25240 - NAVAJO NATION PEACEMAKING BUILDING & AMPITHEATER

Addendum **ADD-1.0**

ADDENDUM 001

A1 FLOOR PLAN - CODE+LIFE SAFETY BLDG B

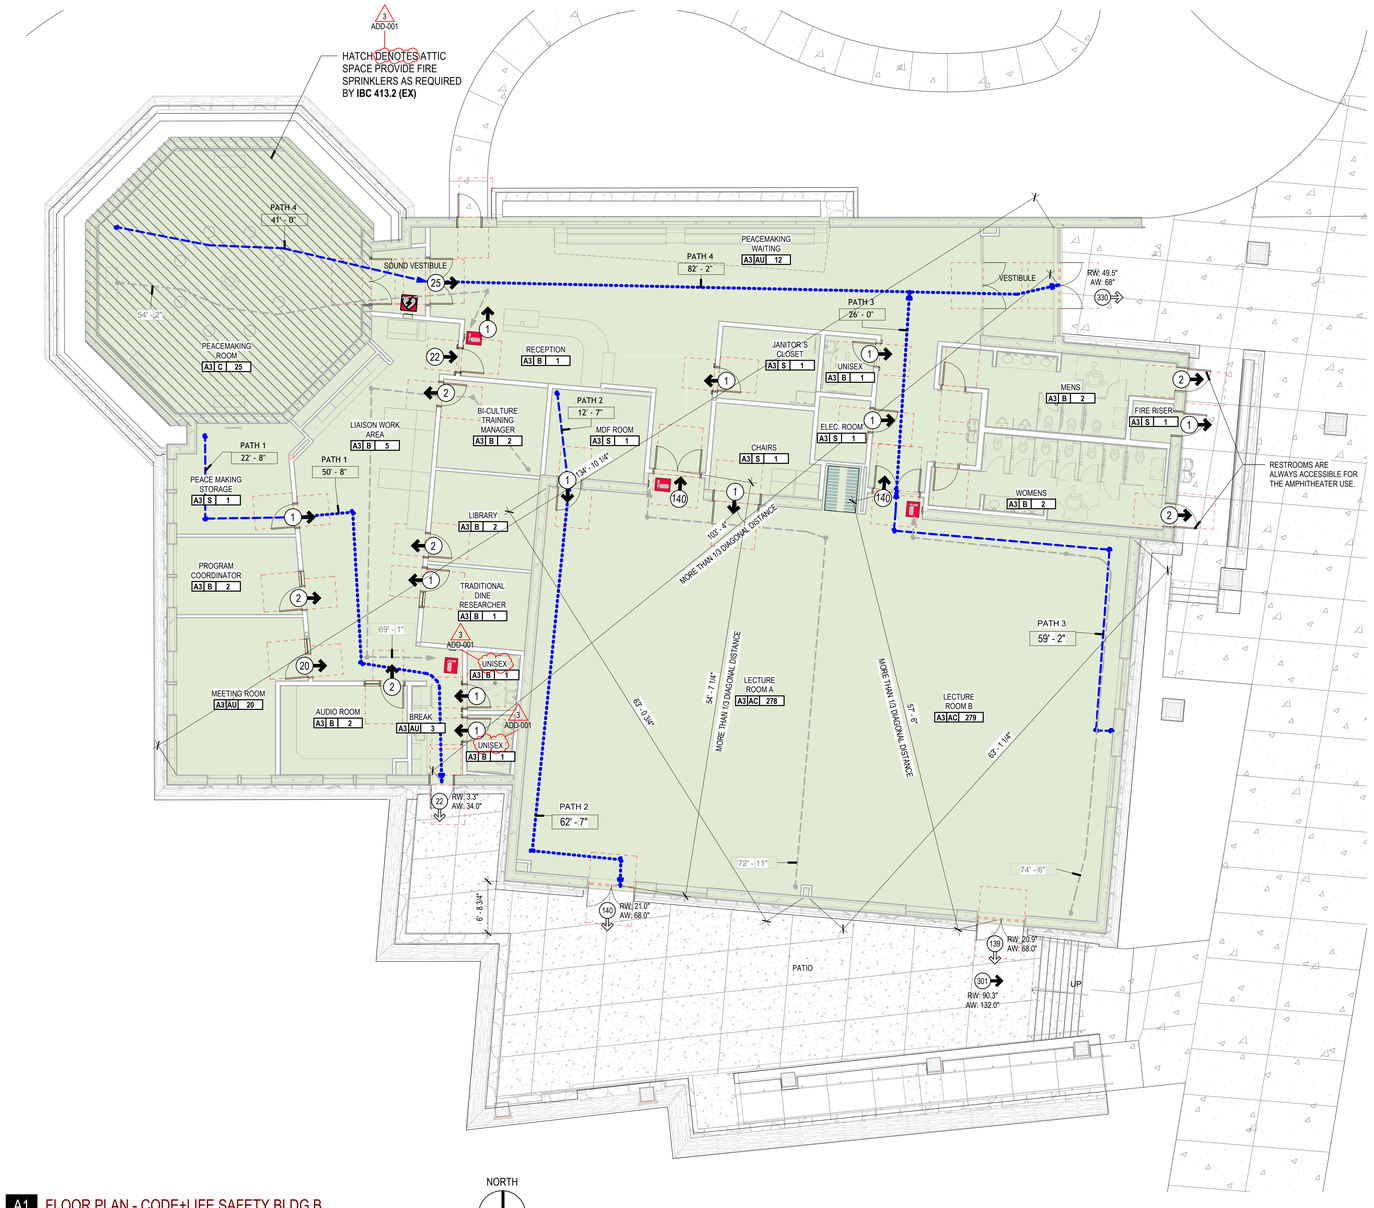
G101 *11/11/2026*	CODE + LIFE SAFETY - BUILDING B Relabeled restrooms to Unisex
AS100 *11/11/2026*	OVERALL SITE PLAN Added parking calculations
AS300.0 *11/11/2026*	AMPHITHEATER ANNOTATED PLAN Companion seat measurements added
A120.1 *11/11/2026*	ANNOTATED PLAN - BUILDING B Restrooms labels changed to Unisex, window tags changed. Added reference to Alternate #3 for fire pit removal
A120.2 *11/11/2026*	DIMENSION AND WALL TYPES - BUILDING B Restroom labels changed to Unisex
A120.3 *11/11/2026*	FINISH PLAN - BUILDING B Restroom labels changed to Unisex
A120.5 *11/11/2026*	FURNITURE PLAN - BUILDING B Restroom labels changed to Unisex, seating dimensions revised
A320.1 *11/11/2026*	BUILDING SECTIONS - BUILDING B Restroom labels changed to Unisex
A420.3 *11/11/2026*	ENLARGED PLANS + INT. ELEVATIONS - BUILDING B Restroom labels changed to Unisex

OVERALL UTILITY PLAN

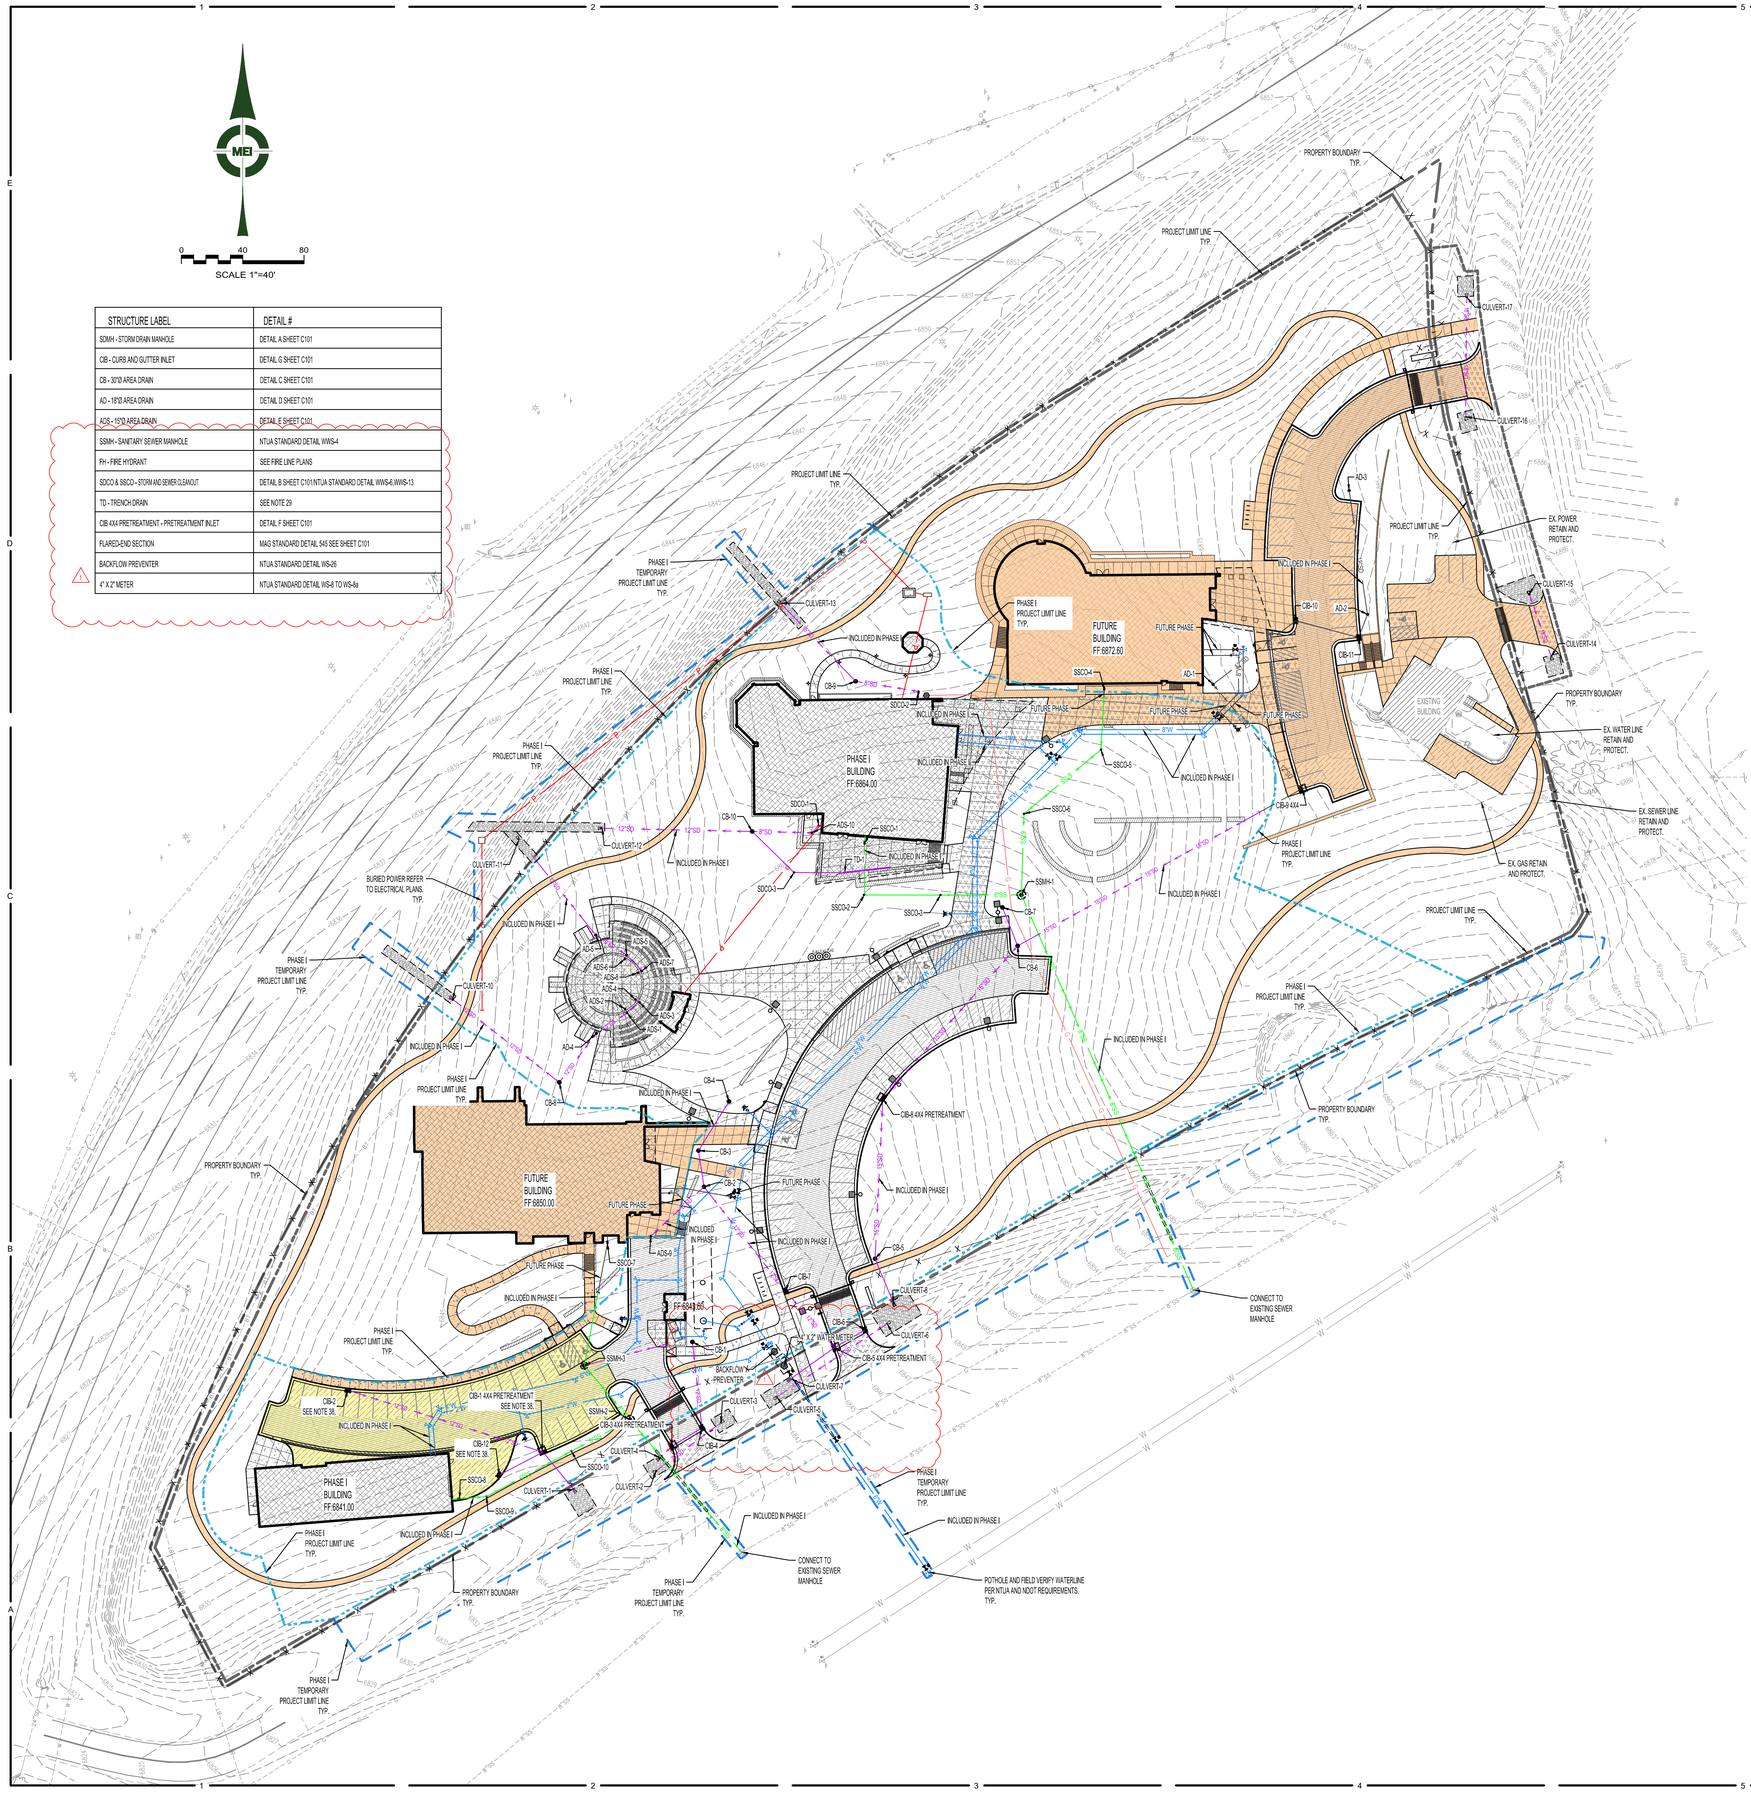
Sheet CU300– Refer to the Attached Sheet.
1- Updated callouts for water structures.

WATER PLAN & PROFILE

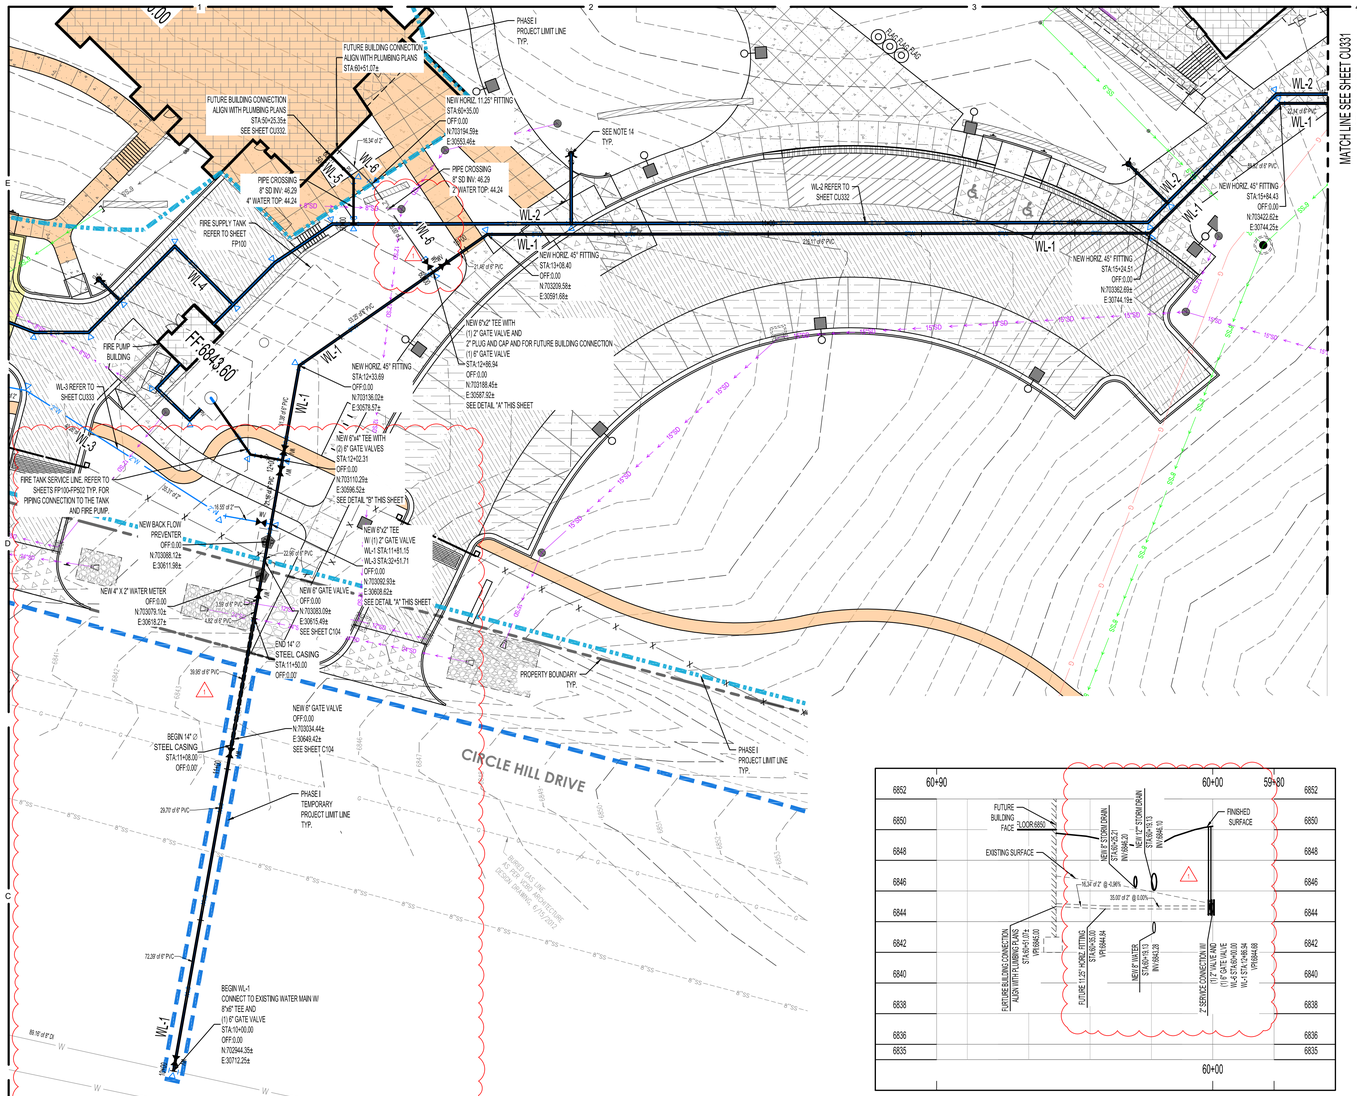
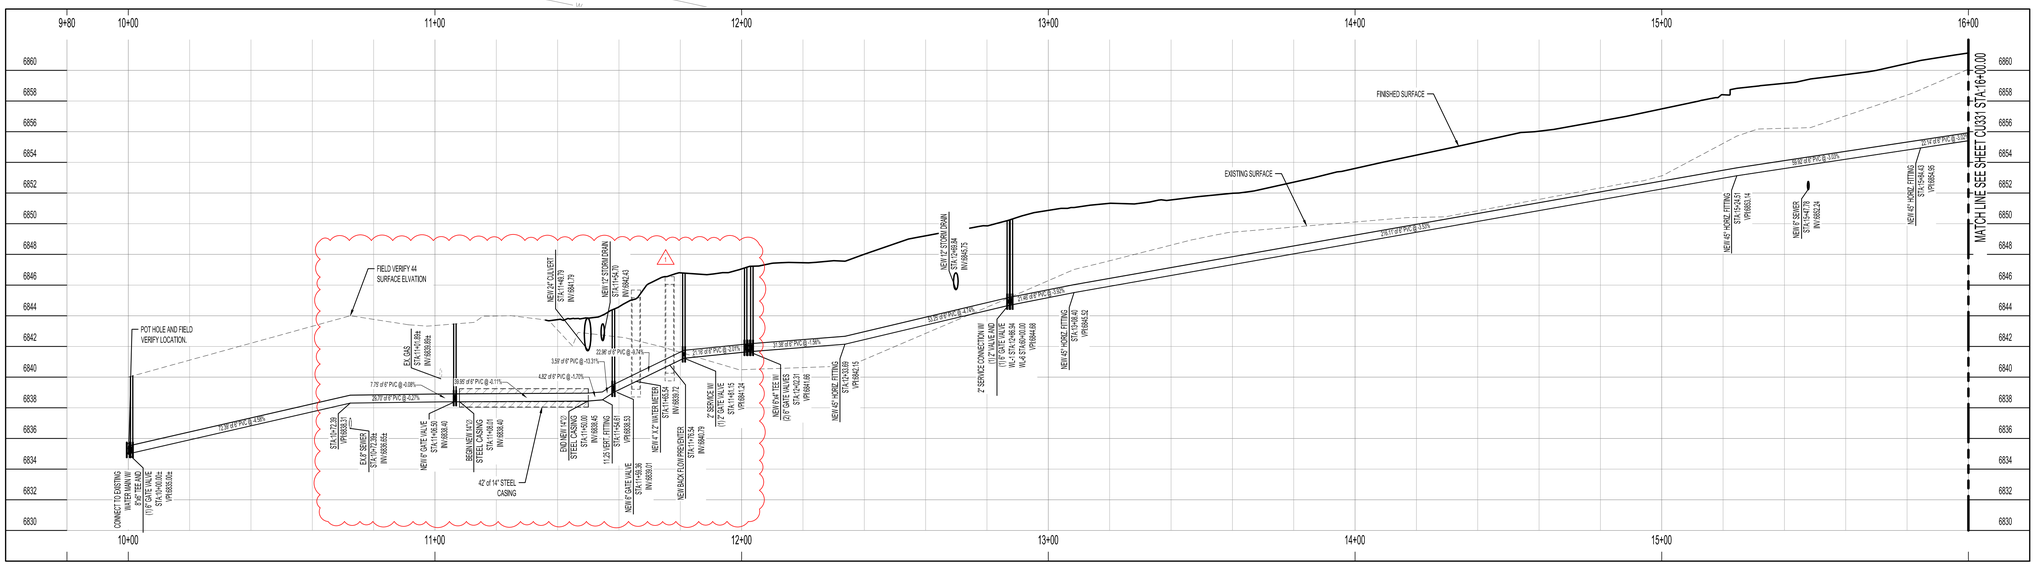
Sheet CU330 - Refer to the Attached Sheets:
1- Updated location for Water meter and Backflow preventer.
2- Updated profile for WL-1.
3- Removed 2" Water Meter.

WATER PLAN & PROFILE

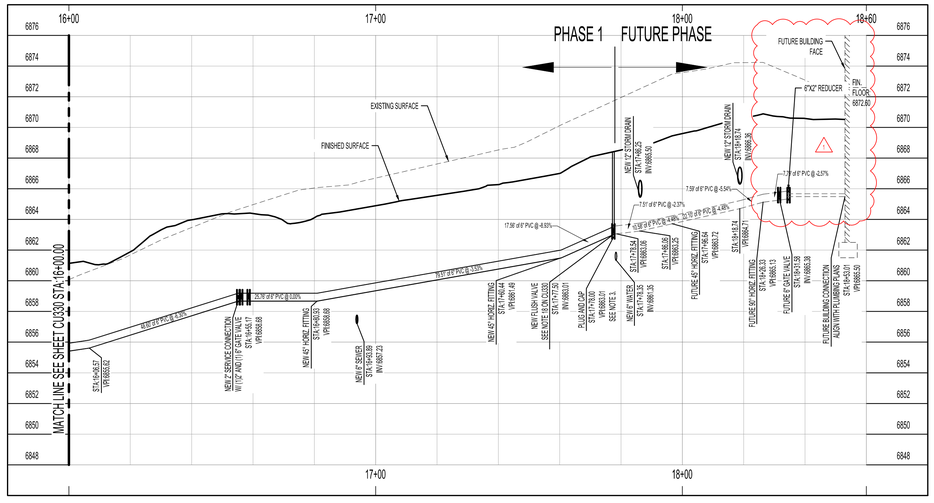
Sheet CU331– Refer to the Attached Sheet.
1- Removed 2" Water Meter.

WATER PLAN & PROFILE

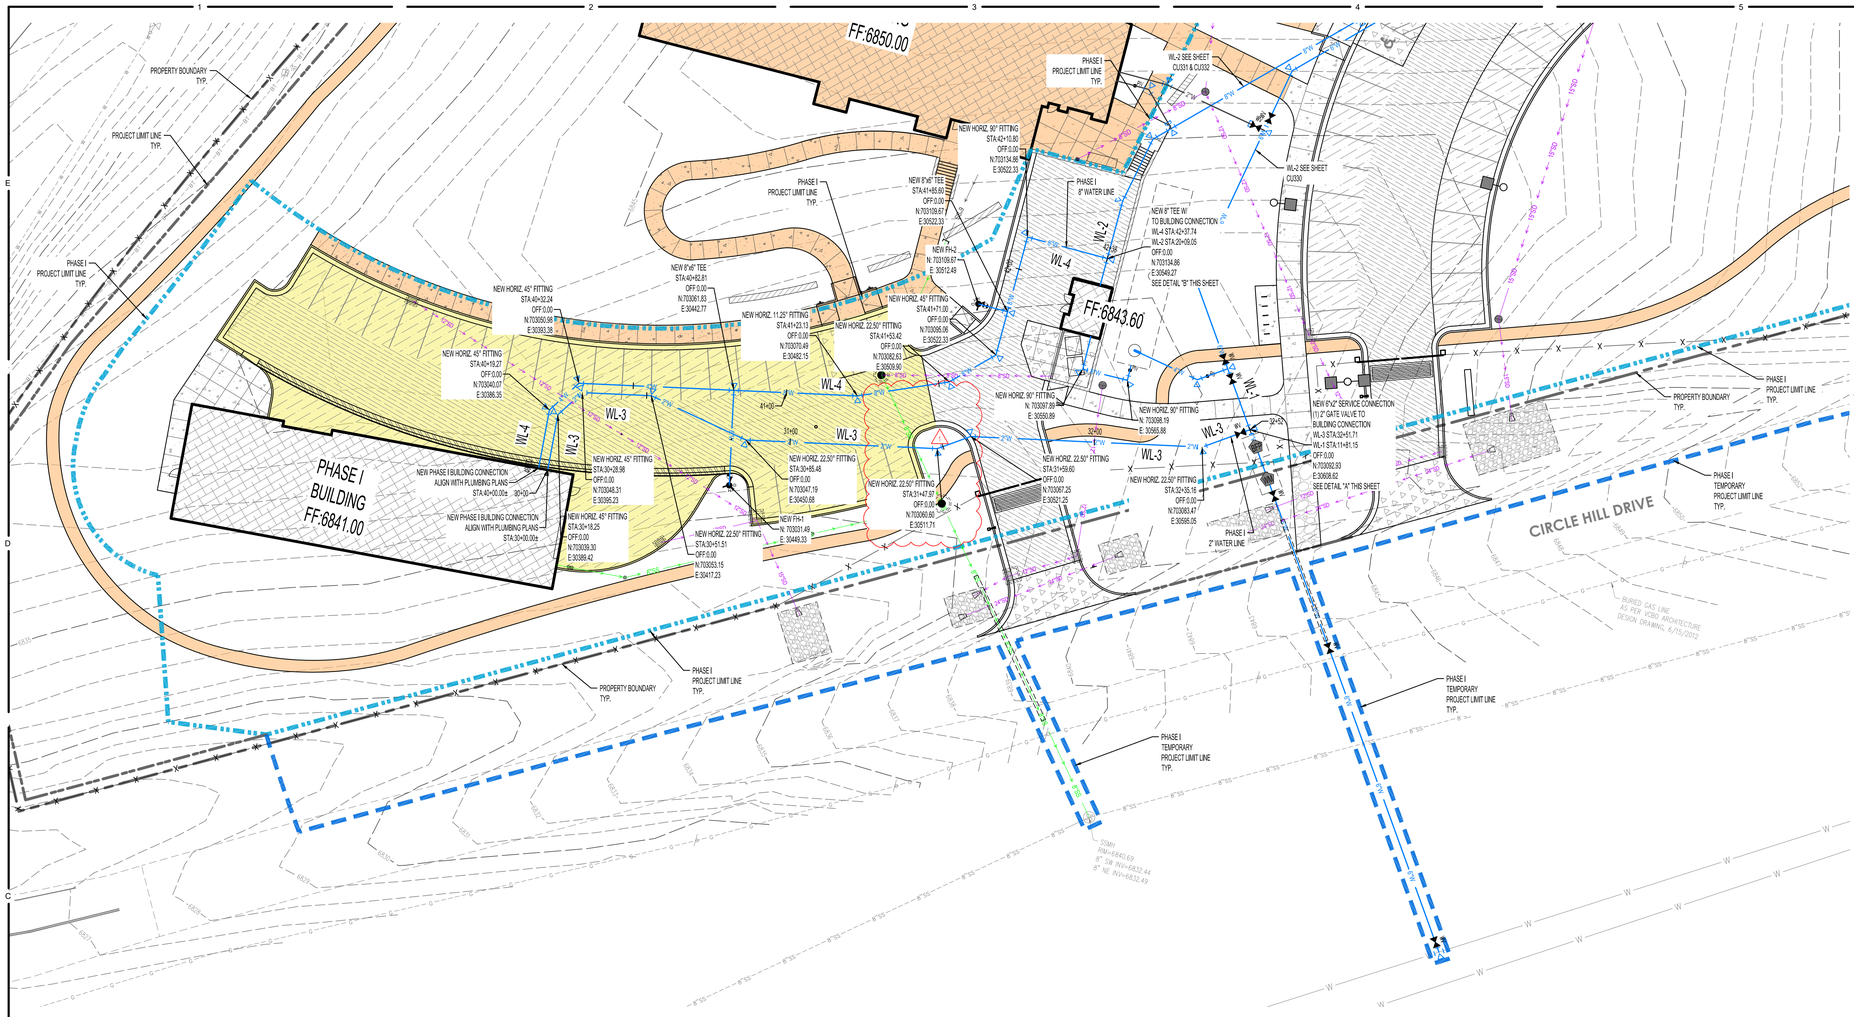
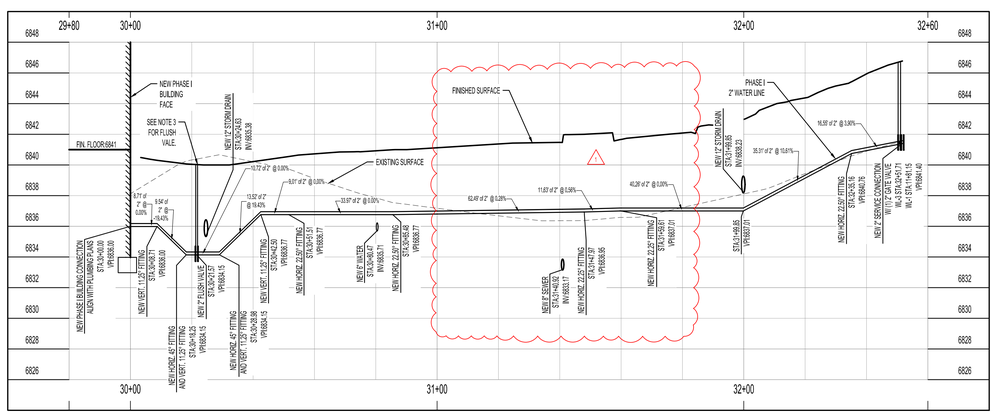
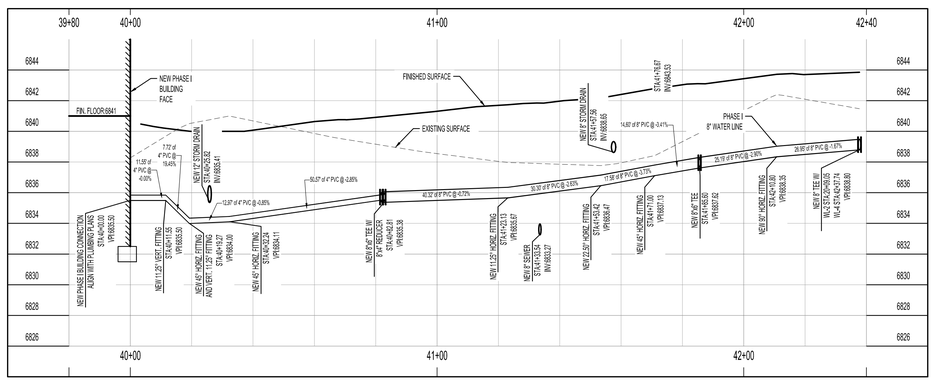
Sheet CU333– Refer to the Attached Sheet.
1- Removed 2" Water Meter.
